**City of Ketchum
Planning & Building**

**STAFF REPORT
KETCHUM PLANNING AND ZONING COMMISSION
MAY 7, 2026 MEETING**

PROJECT: 233 Parkway Variance

FILE NUMBER: P25-059

1
A003 Enlarged Site Plan @ Proposed Garage
SCALE: 3/8" = 1'-0"
0 2' 4' 6'

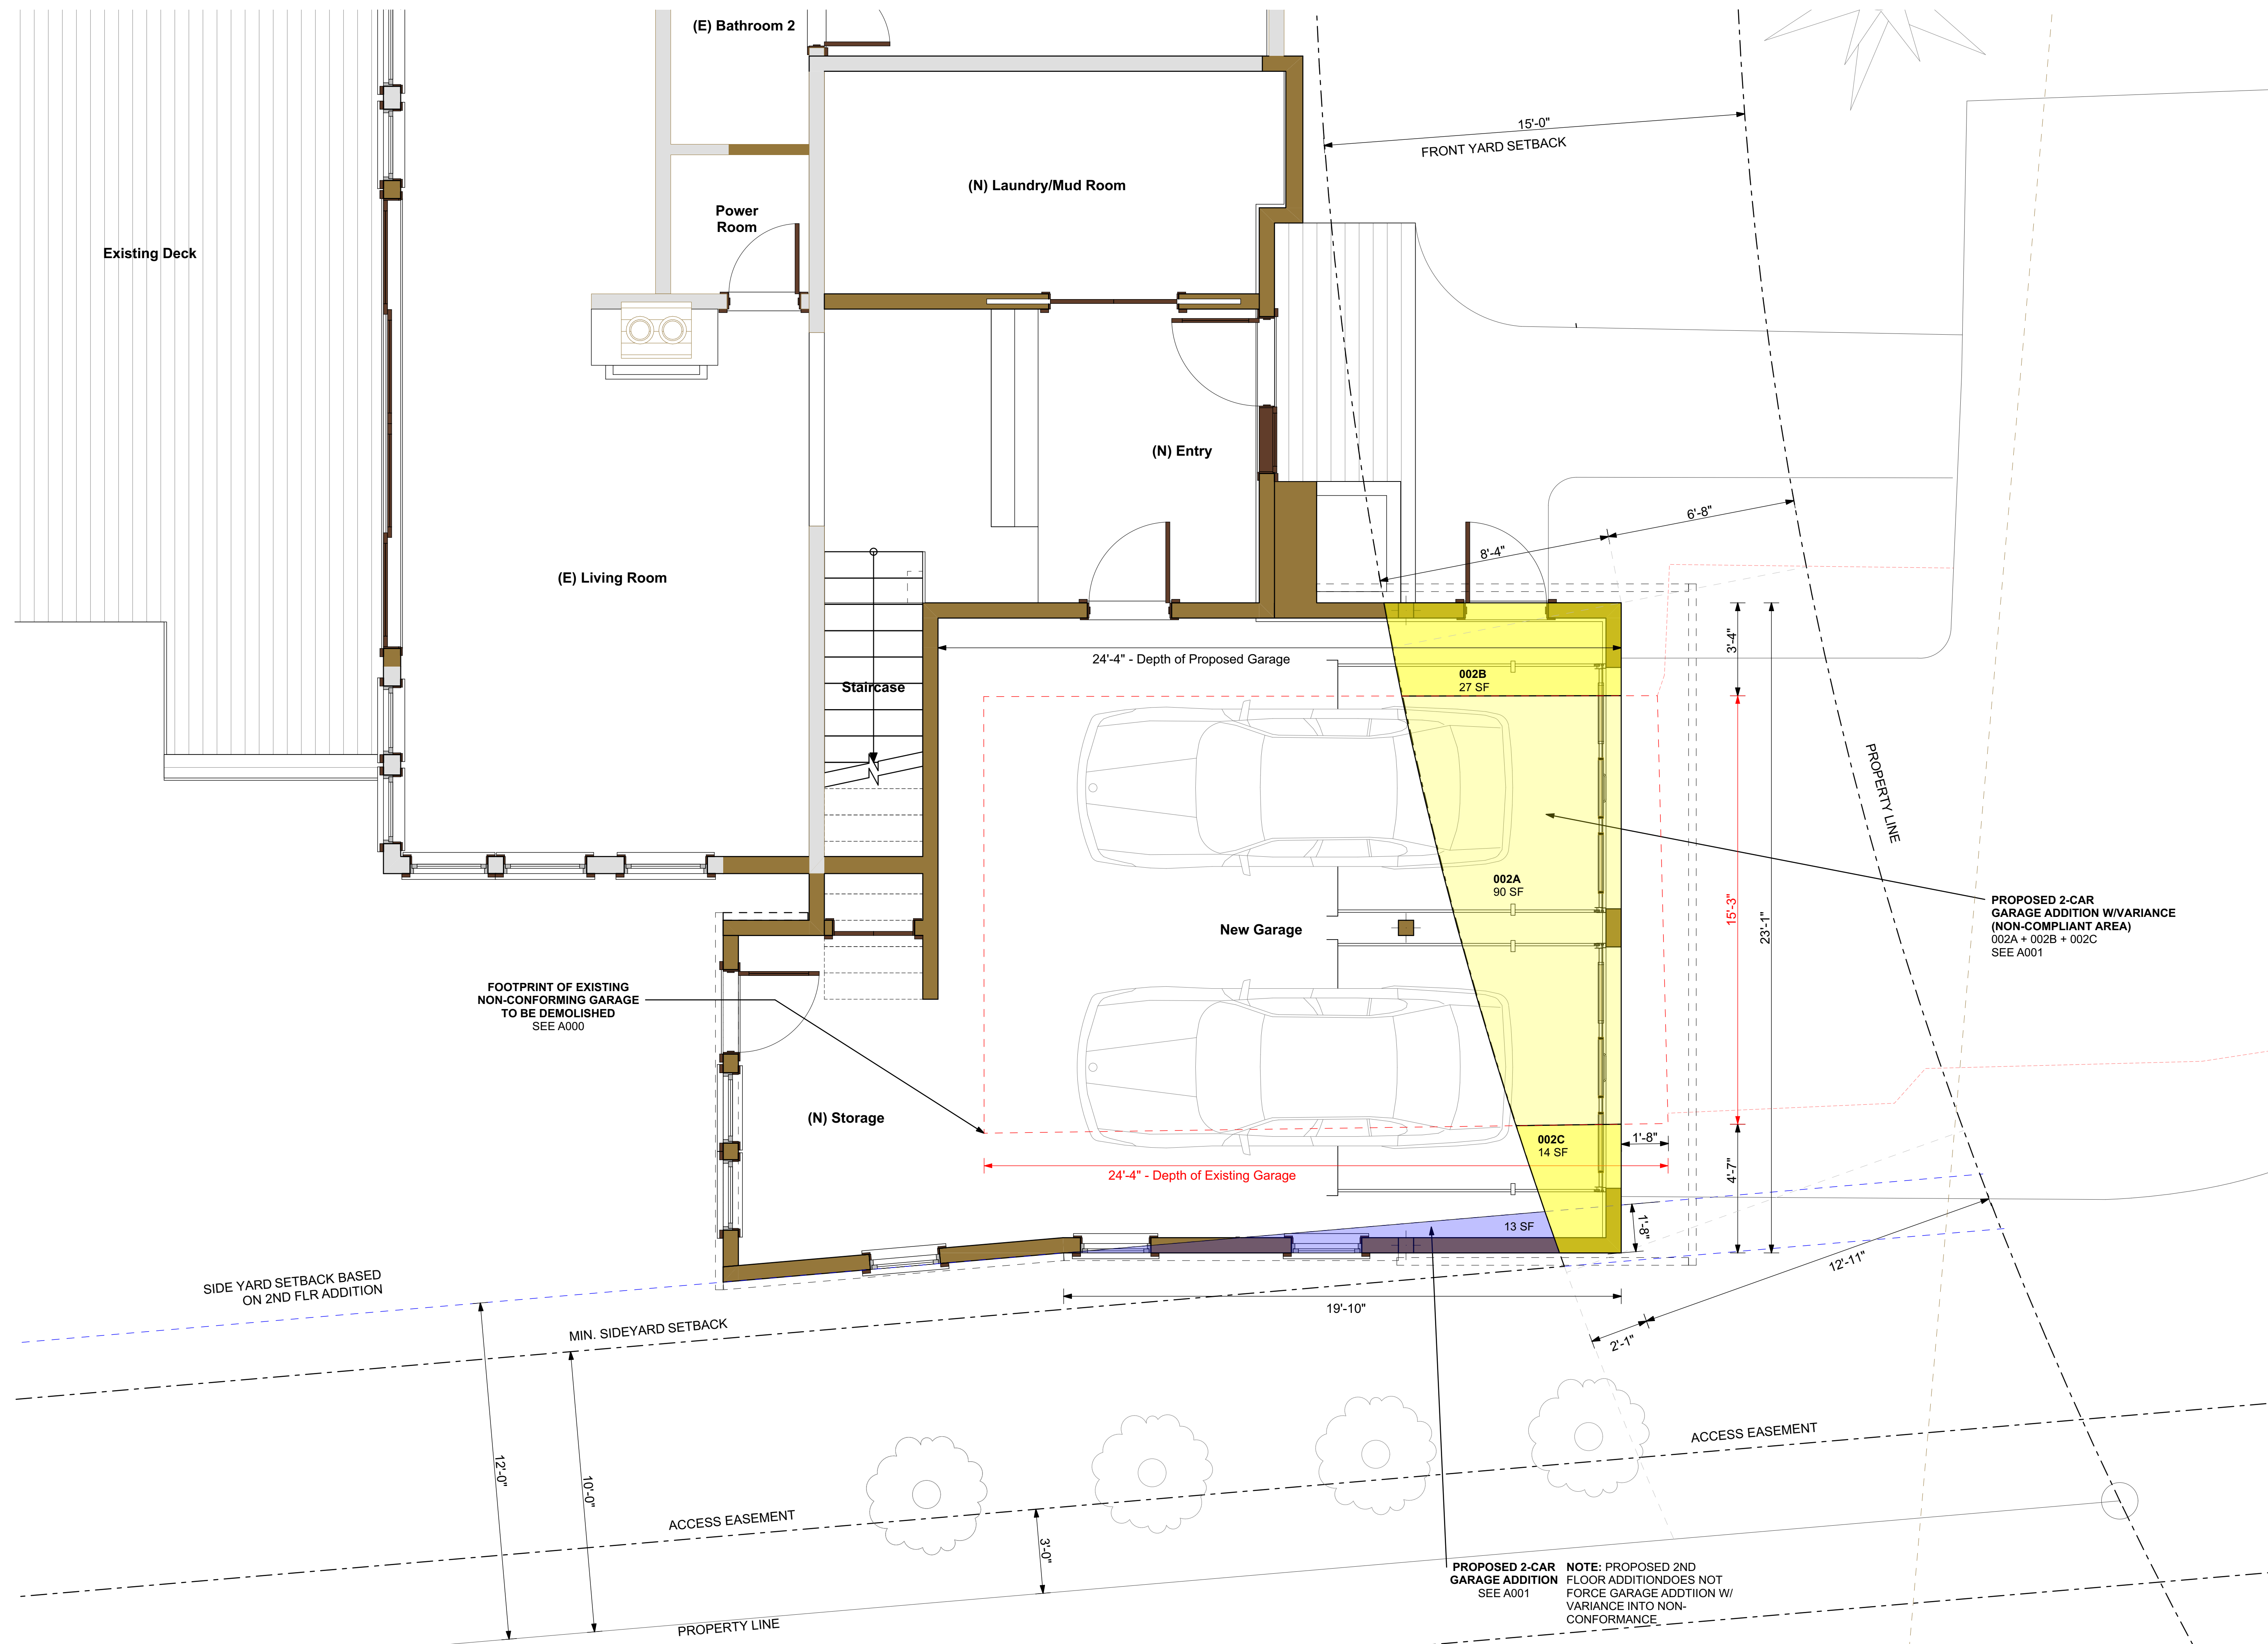
Refer to sheet A001 and A003 for graphic reference of the dimensional information referenced in the narrative.

- ii. In the previous design, the proposed garage addition followed the 10' setback line for the entire 32' length of the garage and storage area, creating a 3'-0" encroachment into the 13'-0" side yard setback at the ground level. The revised garage addition design proposes a reduced 1'-8" side yard encroachment into the 12'-0" minimum setback based on a revised building height of 24'-0". This side yard encroachment further reduces from 1'-8" at the front southeast corner to 0" at 19'-10" from the corner. This minor side yard encroachment has been requested to avoid a greater front yard encroachment variance request at the northeast corner of the garage. Where the ground floor level garage addition extends beyond the minimum needed to park the second vehicle, the addition is fully compliant with the 12' min. side yard setback. The proposed second story level is fully compliant with the 15' front yard setback and the 12' min. side yard setback. At the south facing façade the second story is even further setback from the south property line at 14'-6" and 16'-5" respective of the upper floor corners which provides more than the minimum required separation from both from the public river access path or any future development on the lot to the south.

Option D – Basis for proposed variance request

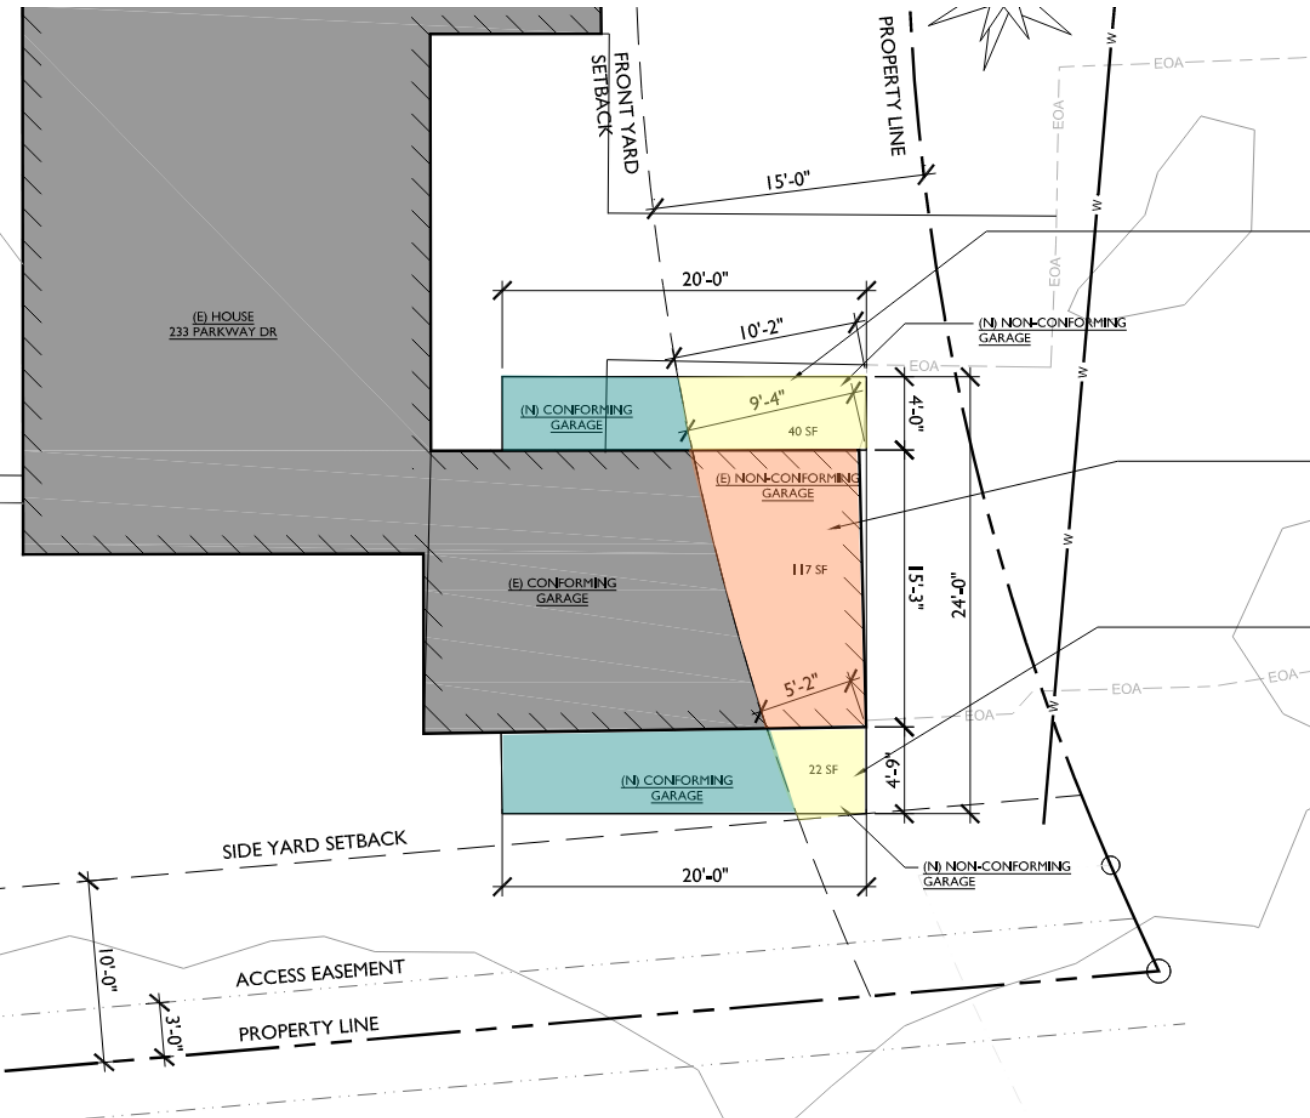
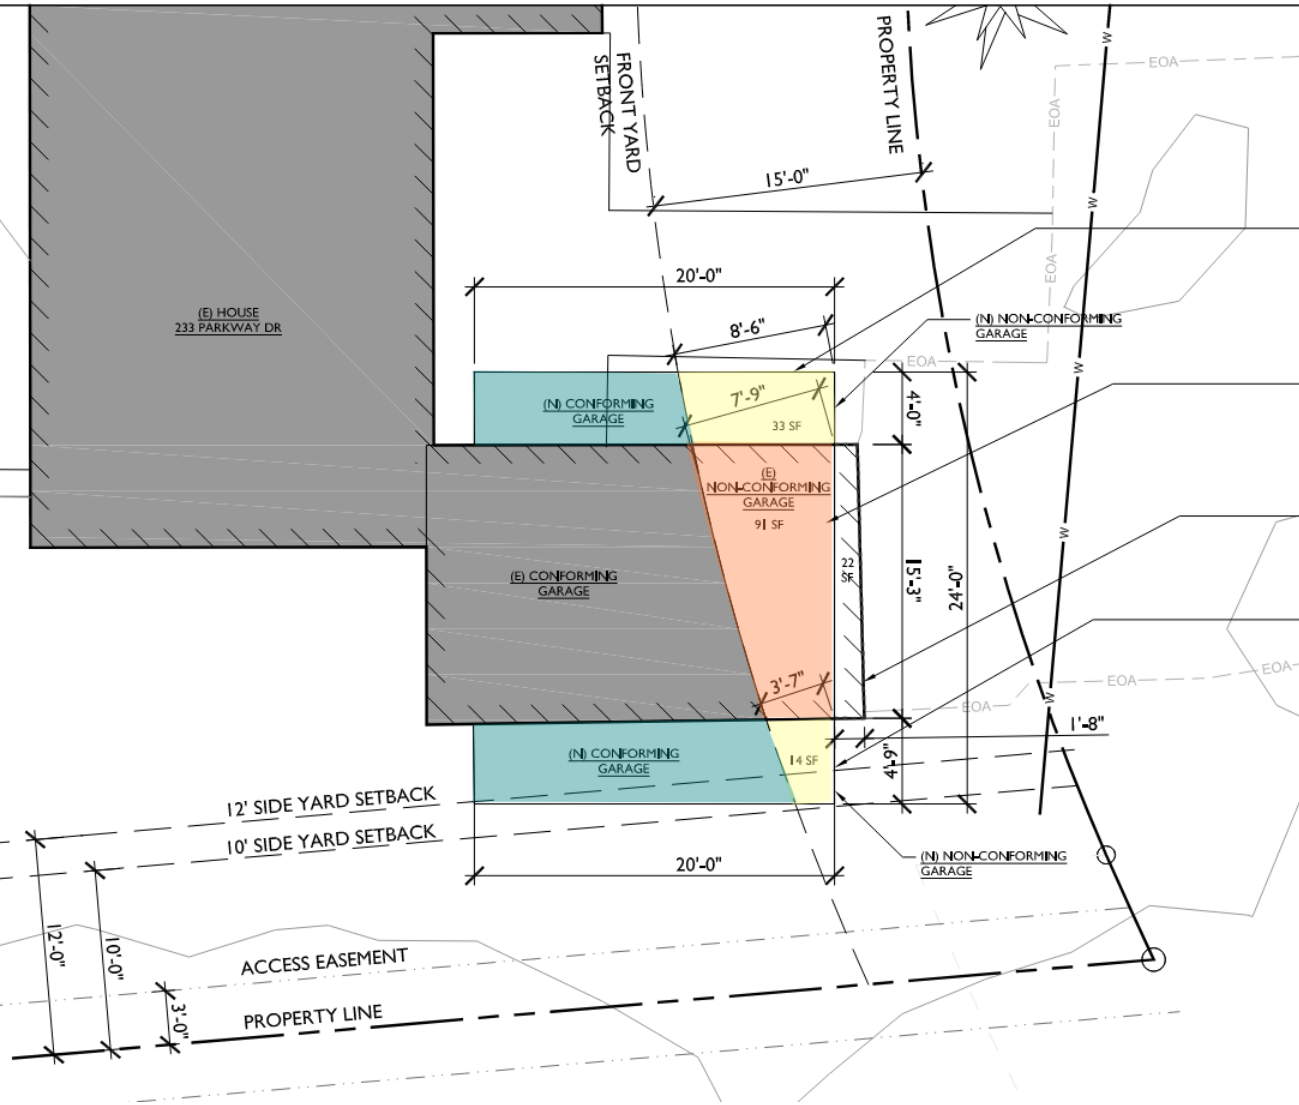
MAX. 91 SF OF EXISTING NON-CONFORMING GARAGE TO REMAIN W/ A REDUCED MAX. ENCROACHMENT OF 7'-9" INTO FRONT YARD SETBACK, REQUIRES VARIANCE TO REBUILD NEW GARAGE IN SAME LOCATION IN ORDER TO PROVIDE GARAGE DOOR(S) FOR TWO VEHICLES

FRONT PLANE OF NEW GARAGE TO BE SET 1'-8" BACK FROM EXISTING GARAGE PLANE RESULTING IN REDUCING THE NON-CONFORMING BUILDING SQUARE FOOTAGE BE 22 SF.

- NET INCREASE OF 21 SF NON-CONFORMING SF FROM 117 SF TO 138 SF
- DECREASED FRONT YARD ENCROACHMENT BY 1'-7" FROM 9'-4" TO 7'-9"
- 30% OF EXISTING GARAGE IS IN NON-COMPLIANCE, 26% OF (N) GARAGE WOULD BE IN NON-COMPLIANCE
- THIS IS MINIMUM NECESSARY TO PROVIDE 2ND OFF-STREET PARKING IN A TWO-VEHICLE GARAGE
